UNITED STATES PATENT AND TRADEMARK OFFICE

APPLICATION NO.	FILING DATE	FIRST NAMED INVENTOR	ATTORNEY DOCKET NO.	CONFIRMATION NO.
09/854,421	05/11/2001	Tomoo Fujioka	Y-182	7682

Office Action Summary

DETAILED ACTION

FIG 1

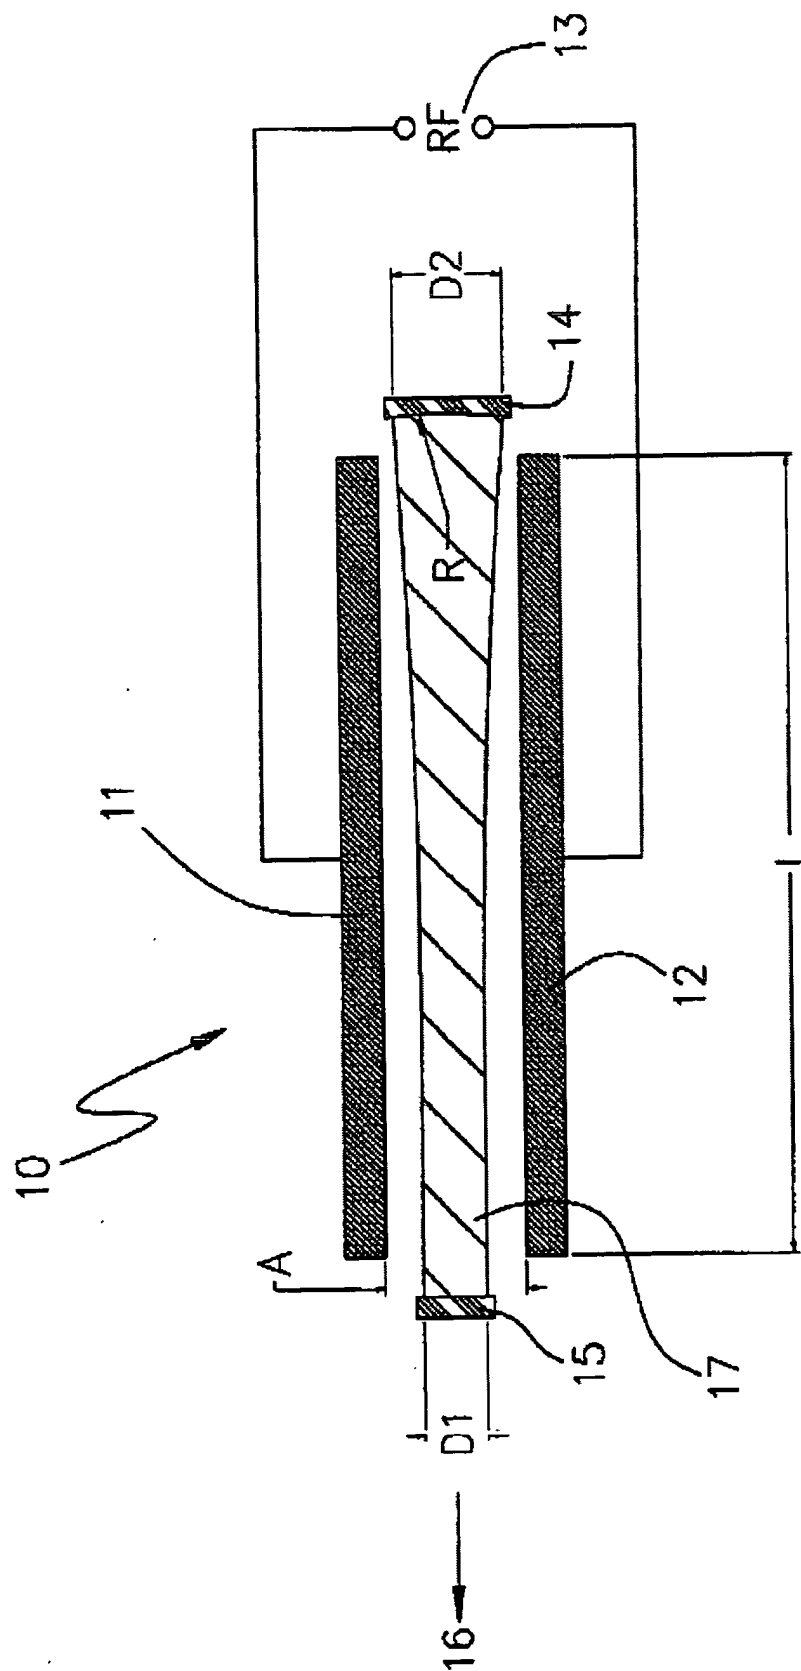
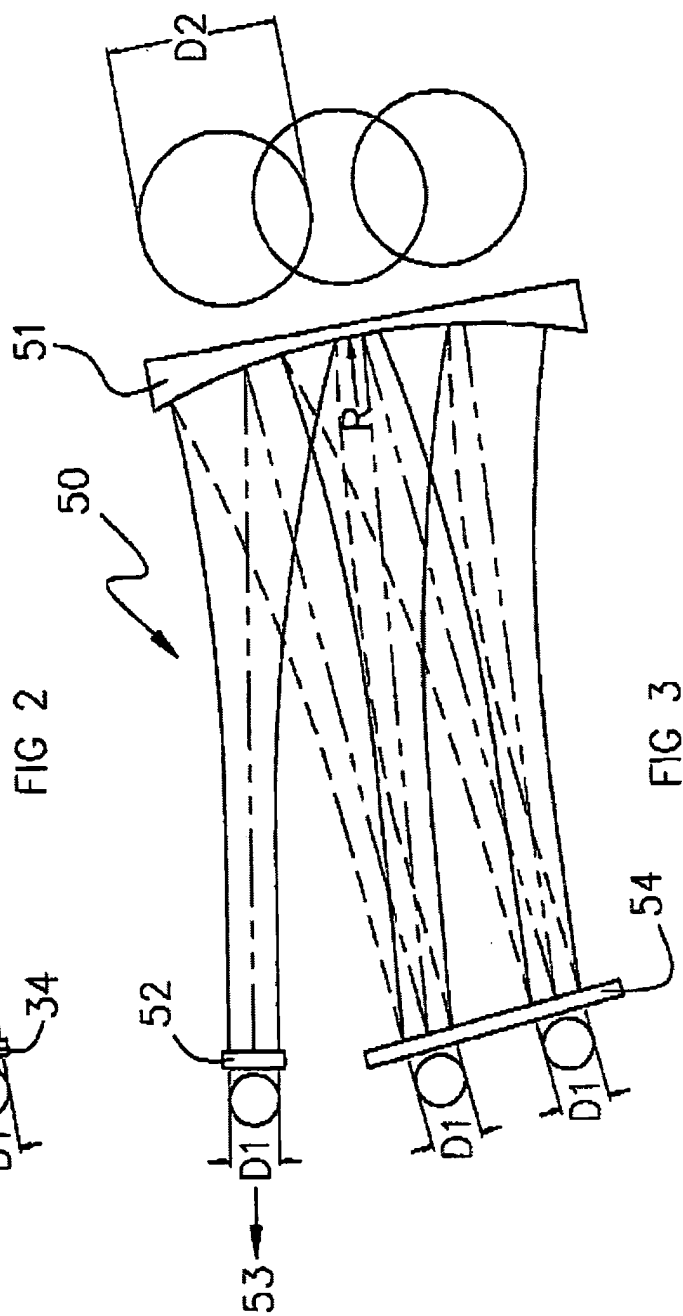
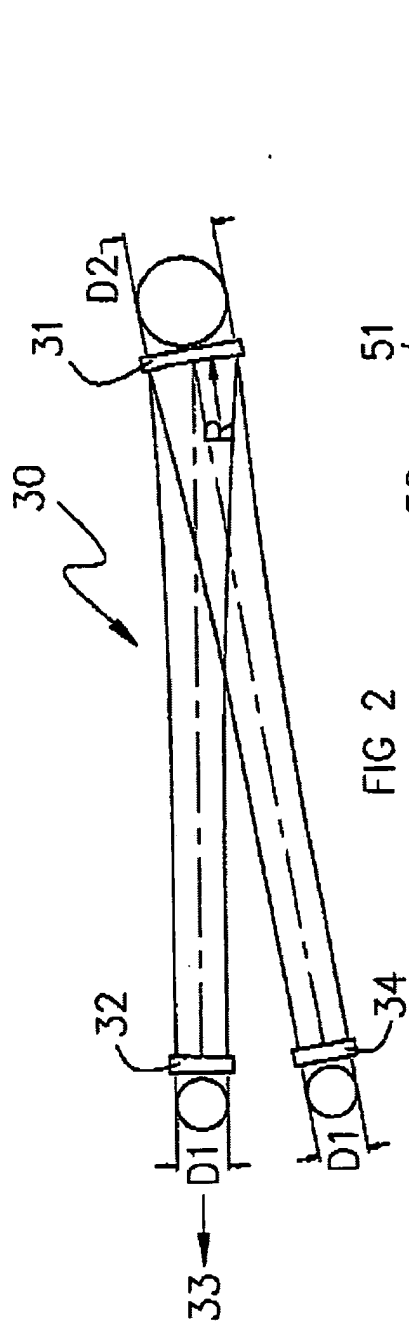
With respect to claim 1, Sukhman et al disclose free-space gas slab laser comprising a gas slab laser (10), a pair of cylindrical electrodes (11, 12), the spacer (99), the gap (40), an output mirror (15) is output coupler only partially reflective emitting laser light beam (16), the Gaussian beam (17), the reflective mirror (14), the diameters (D1 and D2), note cols. 6-13, see figs 1-12. However, Sukhman fails to disclose the w-axicon mirror disposed at the other end of the straight slab and center position. Whereas Holmes et al disclose the w-axicon mirror disposed at the other end of the straight slab and the center position, note cols. 1-5, see figs. 1-6. For the benefit of the w-axicon mirror disposed at the other end of the straight slab and center position, it would have been obvious to one having ordinary skill in the art at the time the invention was made to provide Sukhman with the w-axicon mirror disposed at the other end of the straight slab and the center position as taught or suggested by Holmes.

With respect to claim 3, Sukhman discloses the output laser beam from the output mirror has substantially Gaussian intensity distribution when it is focused by a lens, note cols. 5-6, see fig 1.
